Broadcast Products Technical Bulletin 20-2002-160

SUBJECT: **MANUAL CORRECTION—WHITE BALANCE
ADJUSTMENT**

MODEL: **BVM-D14H1A**
BVM-D14H5A
BVM-D14H1E
BVM-D14H5E
BVM-D14H1U
BVM-D14H5U

**Figure 1**

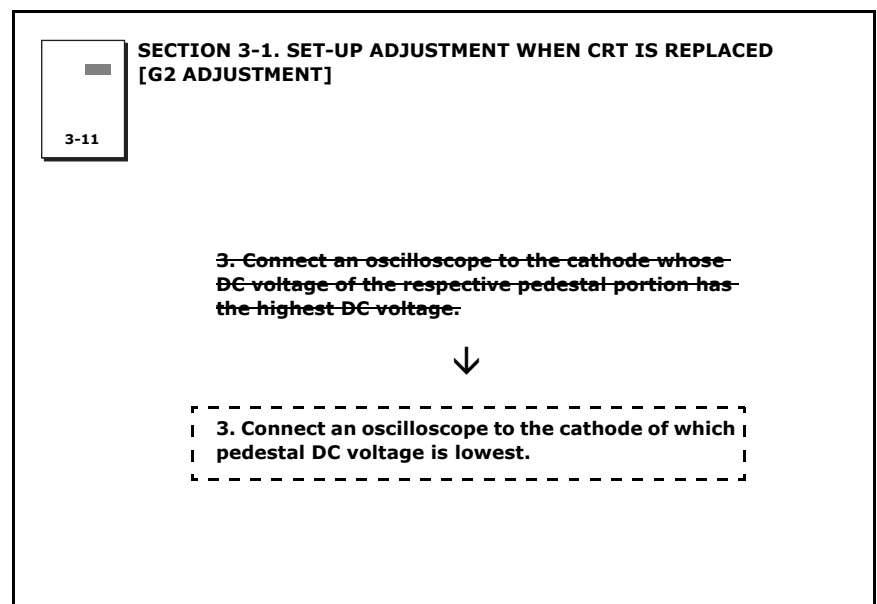
When a unit is used for a long period of time, the G2 voltage may fluctuate, changing the white balance. Correct the BVM-D14H1A Maintenance Manual, 1st Edition, Section 3-1 as shown in Figure 1.
